BVLOS TRIAL IN NON- SEGREGATED AIRSPACE

*TDA EXTENSION:
Stakeholder Feedback*

RE: Goodwood TDA EG D097 - EXTENSION & AMENDMENT

The diagram below shows the proposed, smaller EG D097 **SFC-2000ft** from 24th Sept 2021, with the southern curve being based on the Goodwood ATZ.

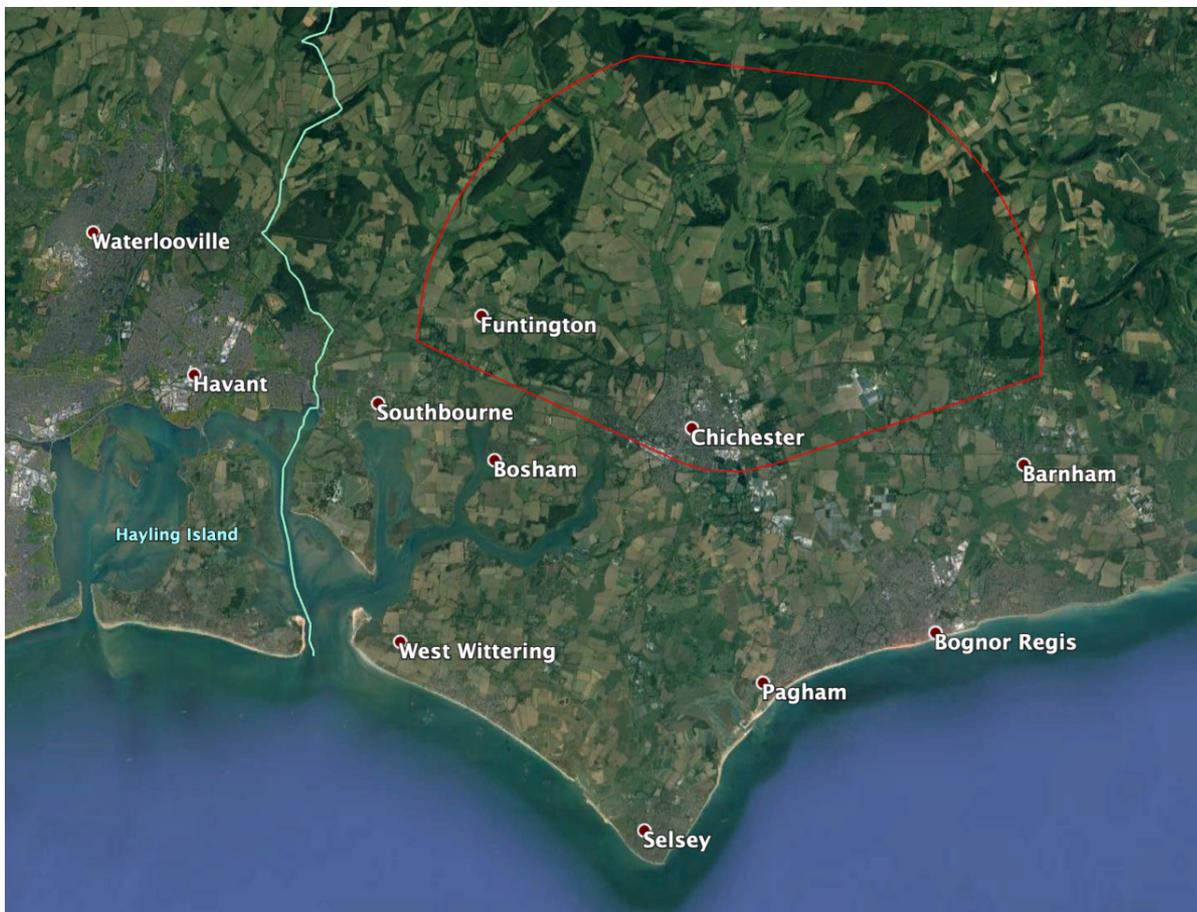
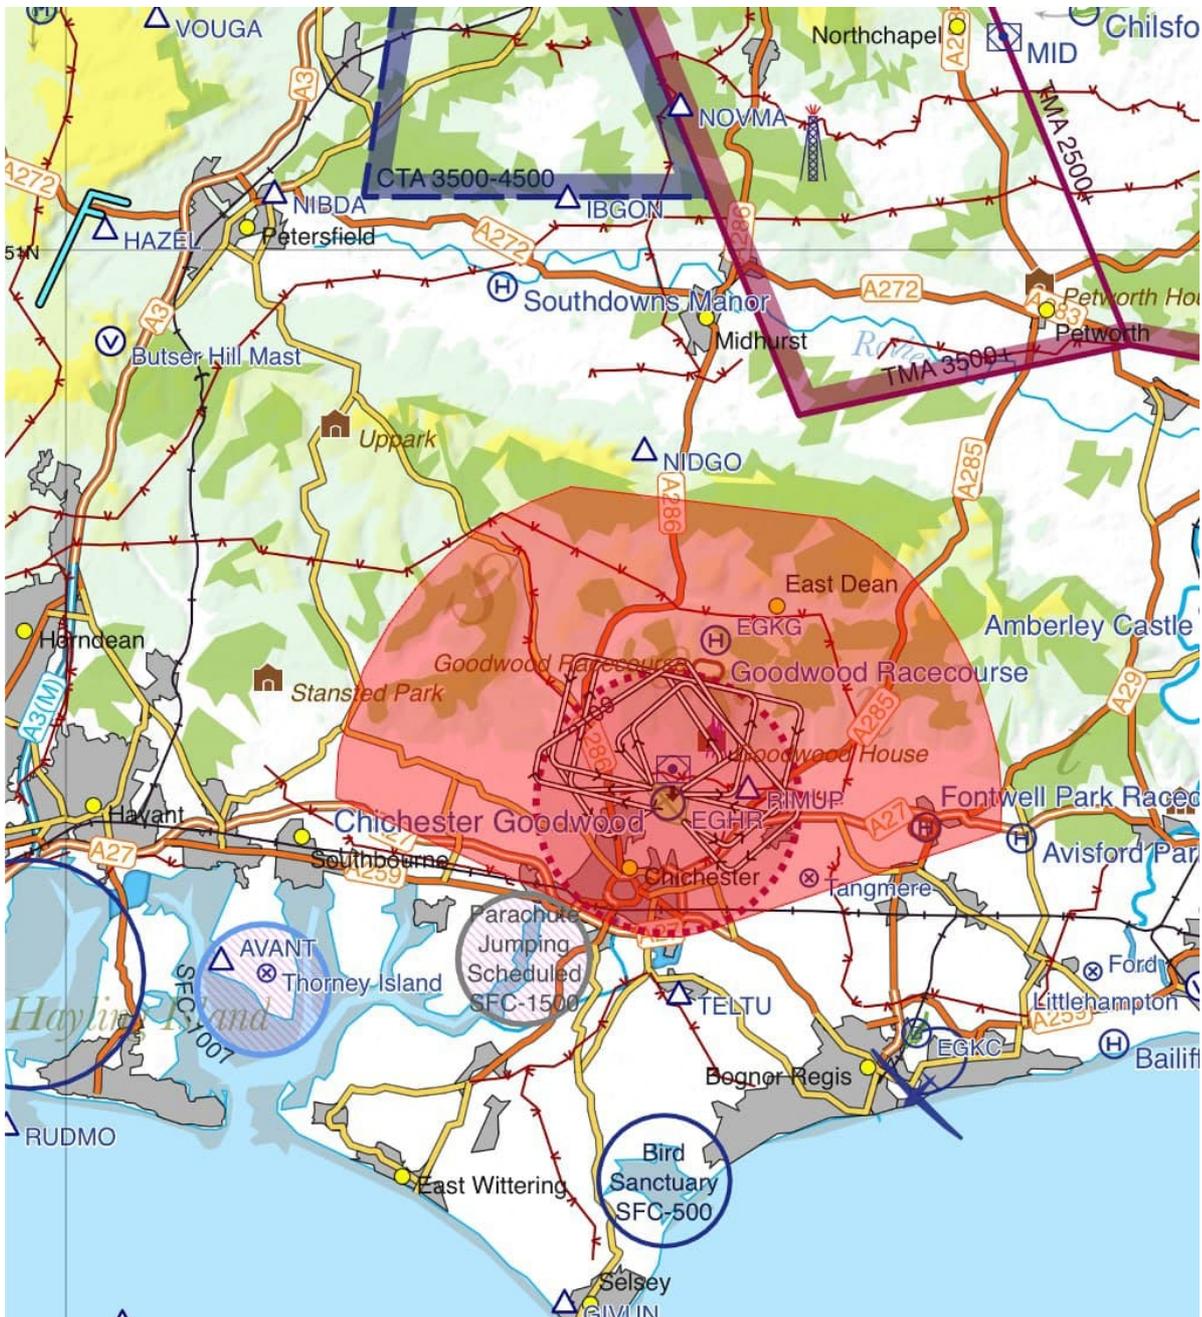
please to see area shrunk in size away from EGKC

Please ignore my message point below about showing the revised TDA on an AIRSPACE chart as I didn't see the additional attachment – for some reason it didn't show on my ipad! Now on my pc I can see it! so, well done and thanks.

We are very please to see that the extent of the TDA has been modified to remove the southern section, as we had suggested in our original engagement submission. This will indeed make a significant contribution to safety for other airspace users in what is a very busy area for GA traffic. Something that I noted when flying through that area just a few days ago and thinking of this pending ACP.

However, once again, as this is an AIRSPACE Change can we ask that you repeat this message to all aviation stakeholders with the revised TDA presented on an AIRSPACE chart, preferably the 1:250,000 scale.
